Applicant:	**Benq**
FCC ID#	**JVP56W10A**
Correspondence Reference Number:	**26857 & 26858**
731 Confirmation Number:	**EA850866**
Date of Original E-mail:	**03/20/2004**

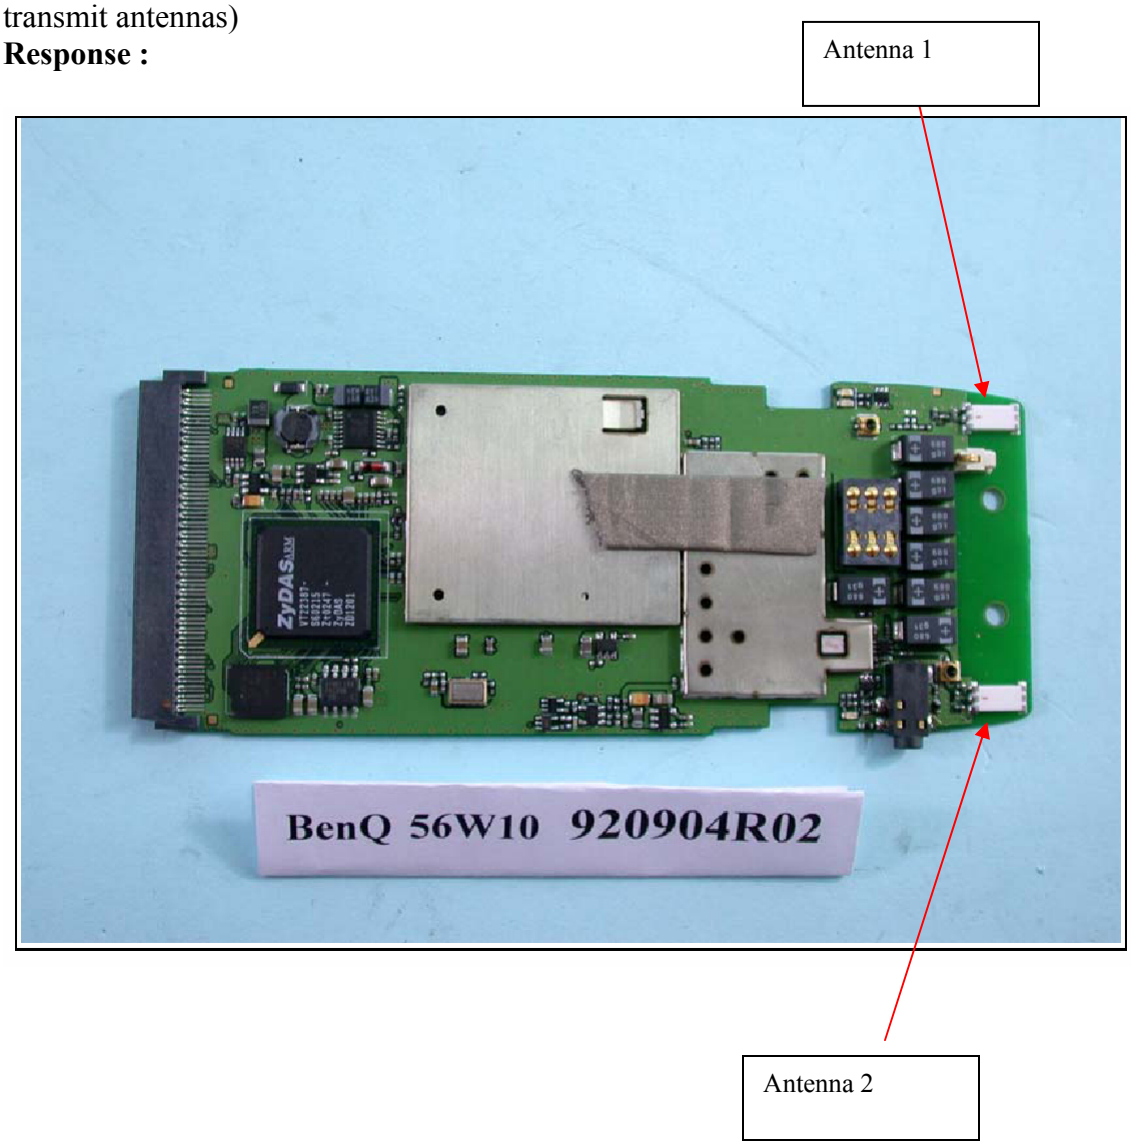
D) The FCC could not locate your answer to question 6.(Correspondence Reference Number: 26540, Question 6:Please show the location on a photo of the device of both transmit antennas)

Response :
